# **Matanuska-Susitna Borough LiDAR & Imagery Project Quality Assurance Report Point Mackenzie Block**

**Written by Rick Guritz**

**Alaska Satellite Facility**

**April 15, 2012**

Figure 54, Initial low vegetation class not as useful at 0-6 feet because it includes ground noise.

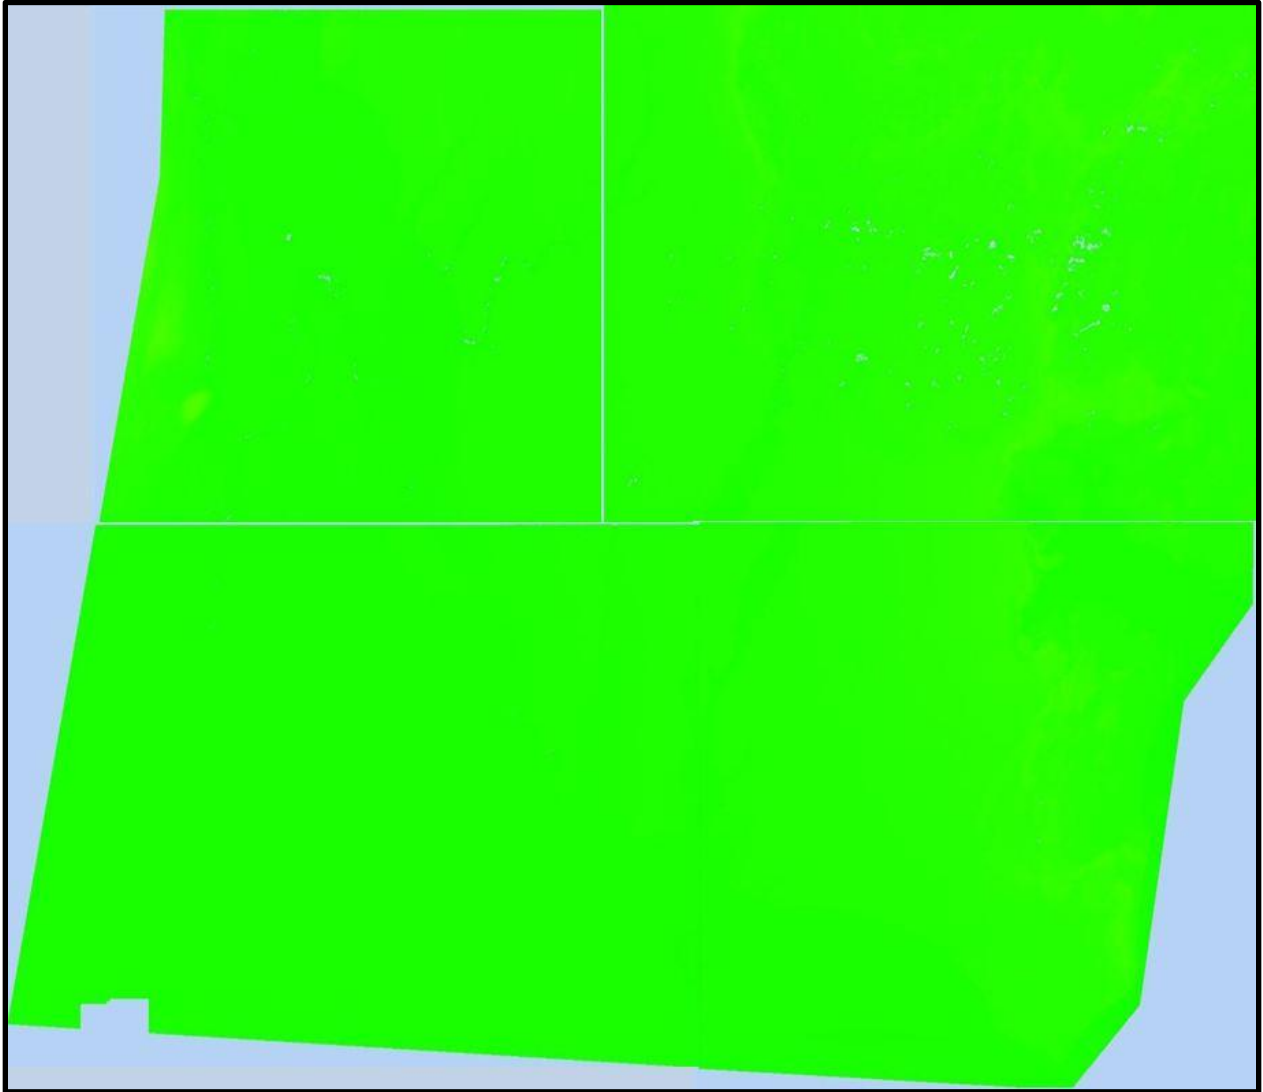
**Low Vegetation not useful as initially defined 0-6 feet** – On 11/23/2011, Aerometric was informed that the low vegetation class as initially defined with structures from 0-6 feet. There was no difference from the spatial extent of low vegetation and ground classes (See Figure 54). Given an accepted noise level in the data of one foot, UAF suggested that they redefine low vegetation as 1 to 6 feet. This should define a tighter spatial extent than ground and actually be useful, instead of redundant.

Figure 55, Fill values around good data inconsistent (Left), corrected (Right).

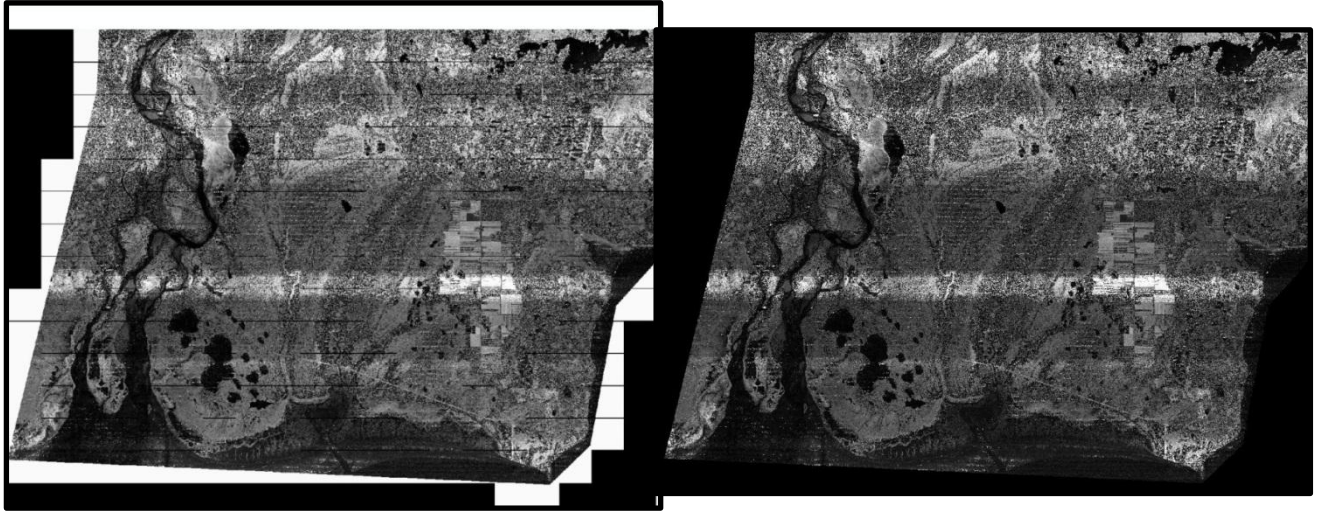
**LiDAR intensity boarder not set to NoData** - On 12/16/2011, UAF reported that fill values outside the block boundary were set to 249 or white and 0 or black (See Figure 55). UAF requested that these should be set to NoData to be similar to the bare-Earth and First-Return gridded products.

Figure 56, Bare-Earth DEM needs trimming (Left), corrected (Right).

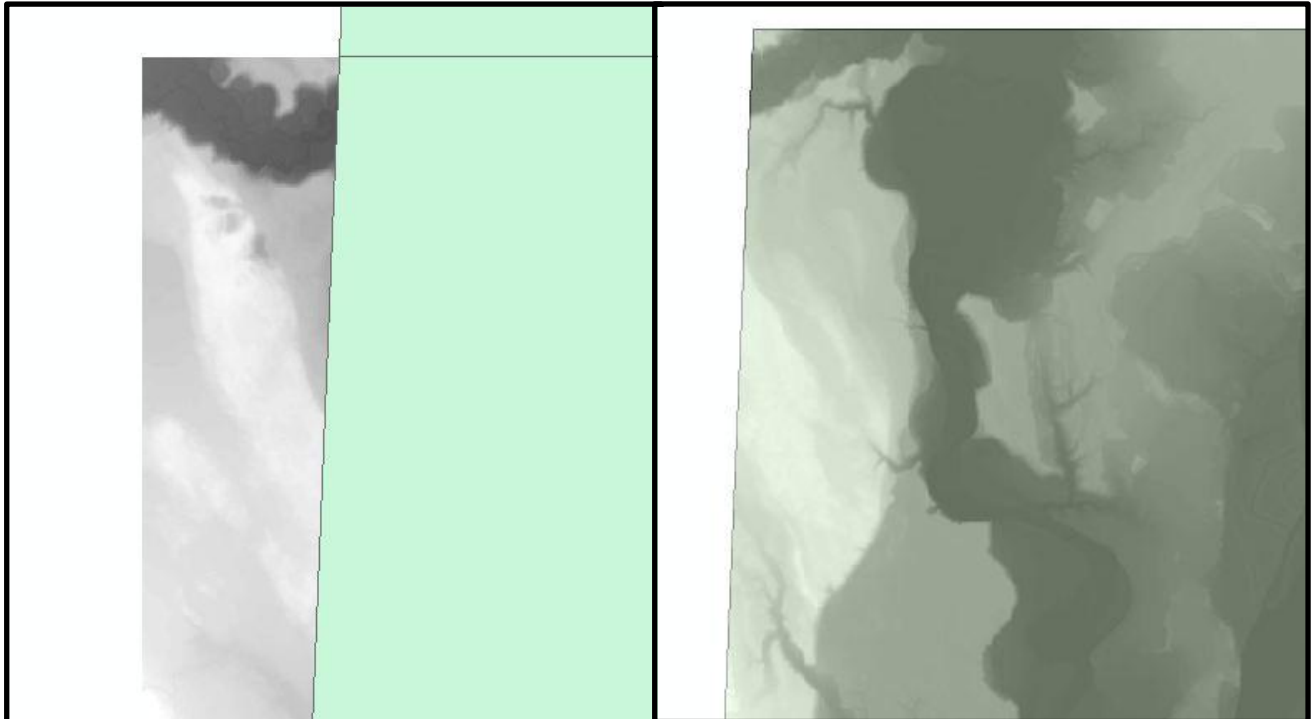
**Bare-Earth DEM needs to be trimmed to block boundary** – On 12/20/2011, UAF reported bare-Earth tile PM\_063 needs to be trimmed to the block boundary (see Figure 56). With data extending beyond

the block boundary, it made for large differences to be detected when subtracting the bare-Earth DEM from the first-return DSM. UAF encouraged Aerometric to produce and deliver a block boundary layer with its tile grids in future deliveries.

Figure 57, Topology Errors in Contours (PM022).

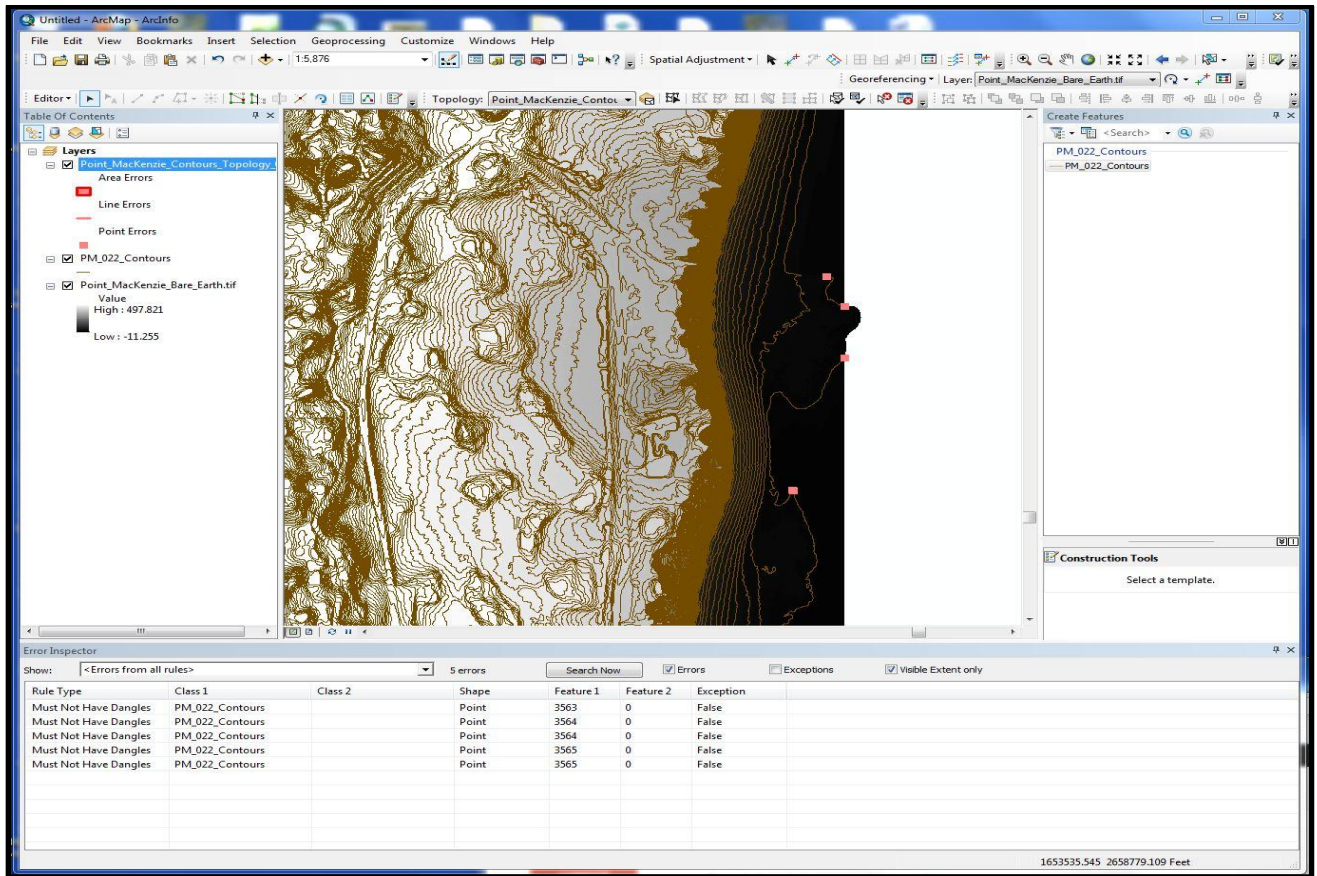
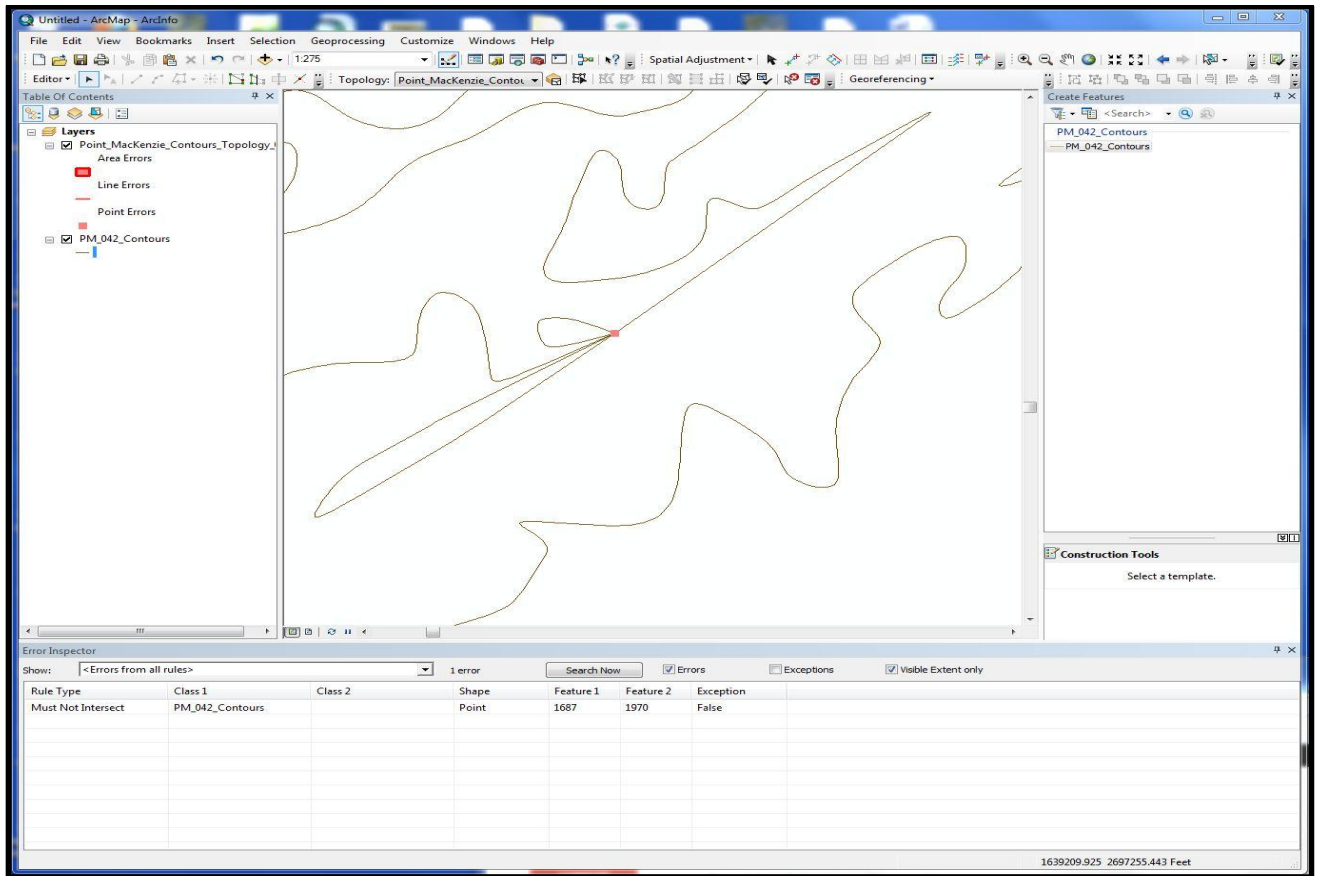
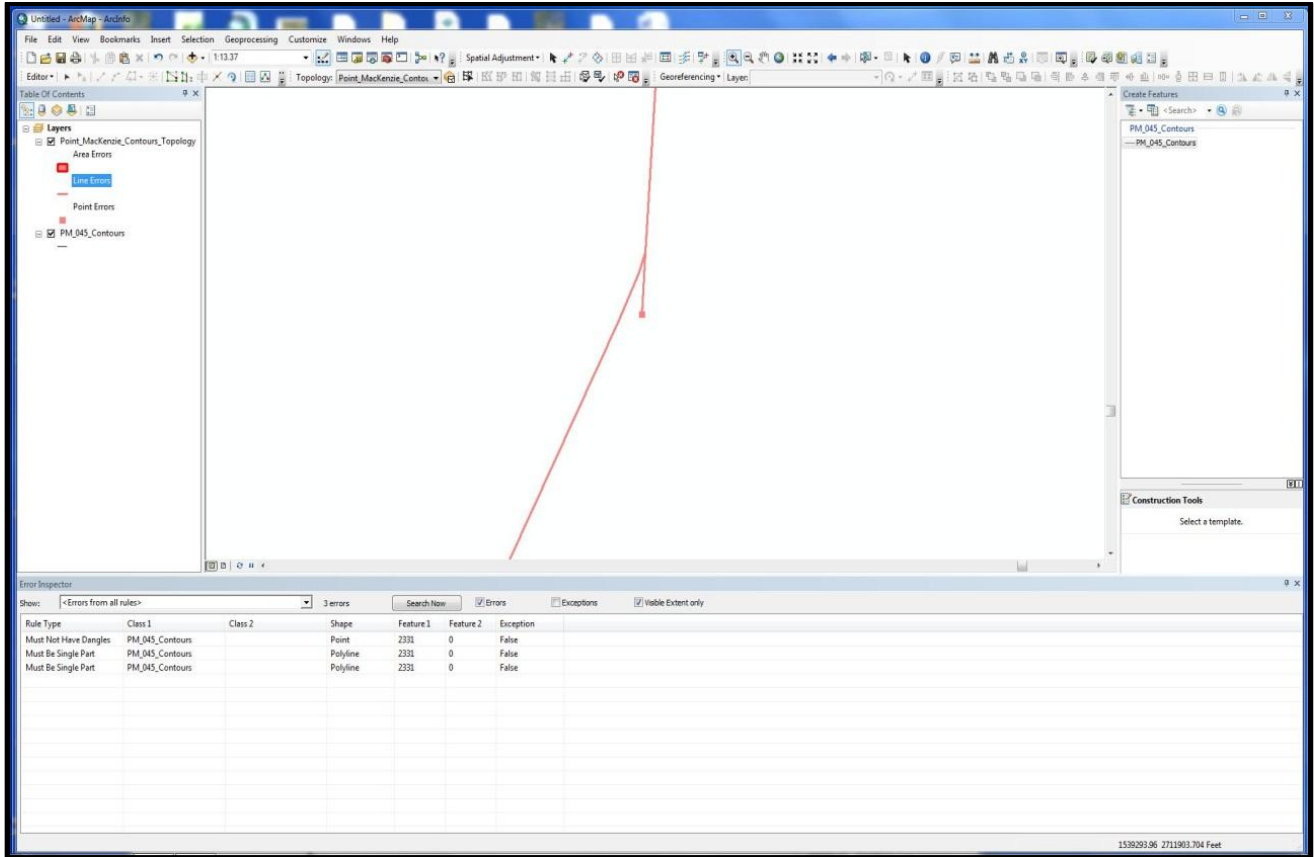
**Contour topology errors** – On 12/28/2011, UAF reported three tiles (PM022, PM042, and PM045) with contour topology errors (See Figure 57-59). This was determined after testing four tiles that contained the largest slopes and topology rules that were supplied by the Matanuska-Susitna Borough staff including: must not overlap, must not intersect, must not have dangles (except at tile edges), and must be single part.

Figure 60, Low vegetation (PM043) Left, corrected Right.

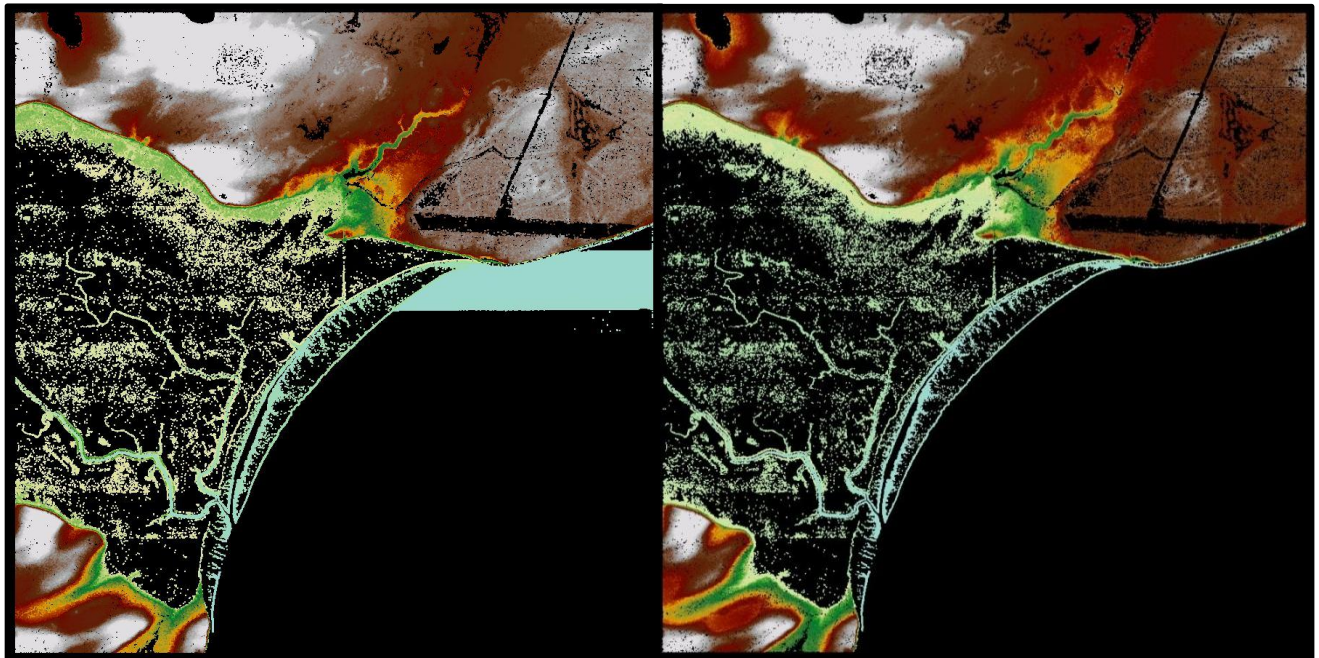
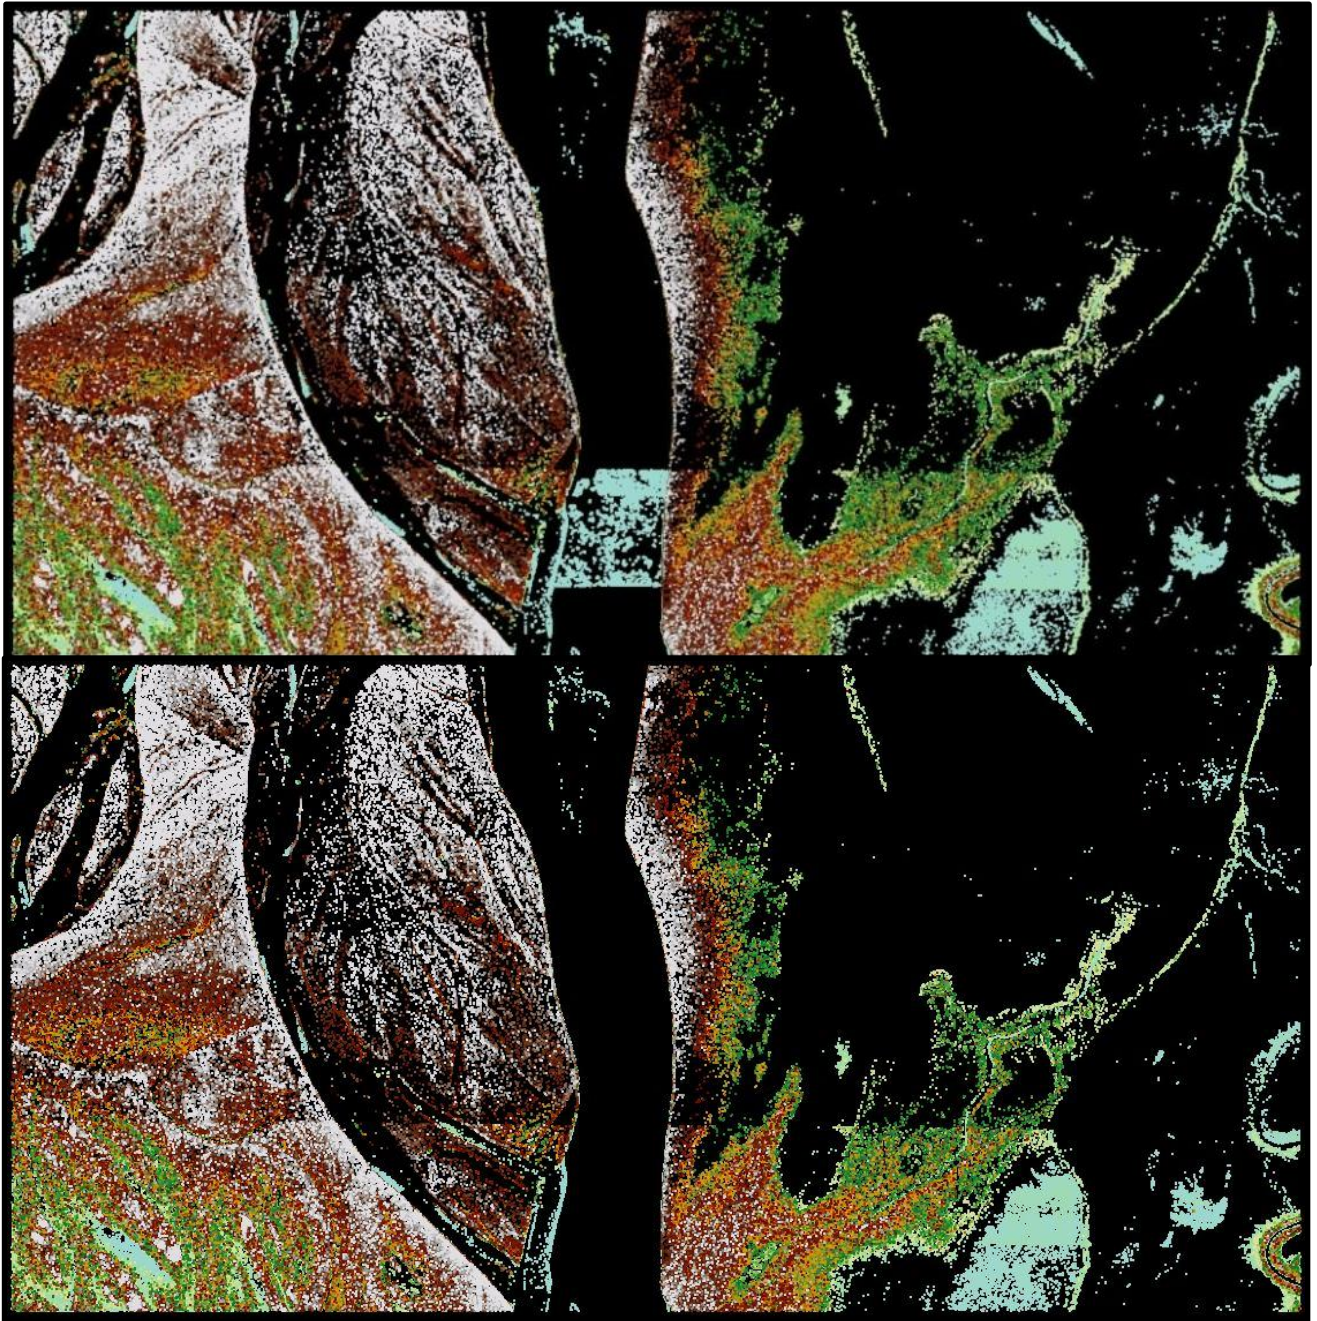
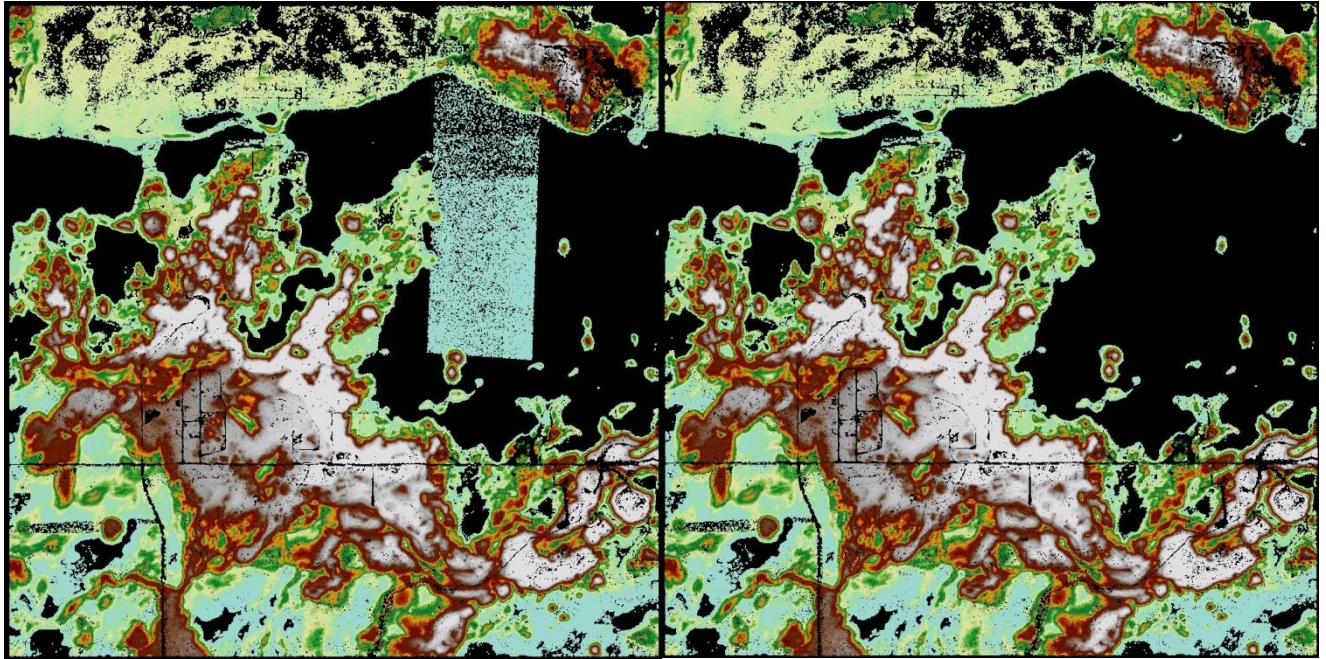
**Low Vegetation errors** – On 03/28/2012, UAF reported additional low vegetation errors that should be fixed (See Figure 60- 62). These include: the northern extent of cook inlet still has low vegetation over water (PM043), a block section of the Susitna River water classified as low vegetation (PM046NE and PM047NW), and a section of Big Lake that is classified as low vegetation (PM070).

**Delivery 6** – Aerometric delivered to UAF by FTP on 03/29/2012 fixes to the requested tiles of new LAS point cloud data to fix the low vegetation errors that were reported. **This final delivery of data completed the final corrections that were needed for acceptance of the Point Mackenzie block.**
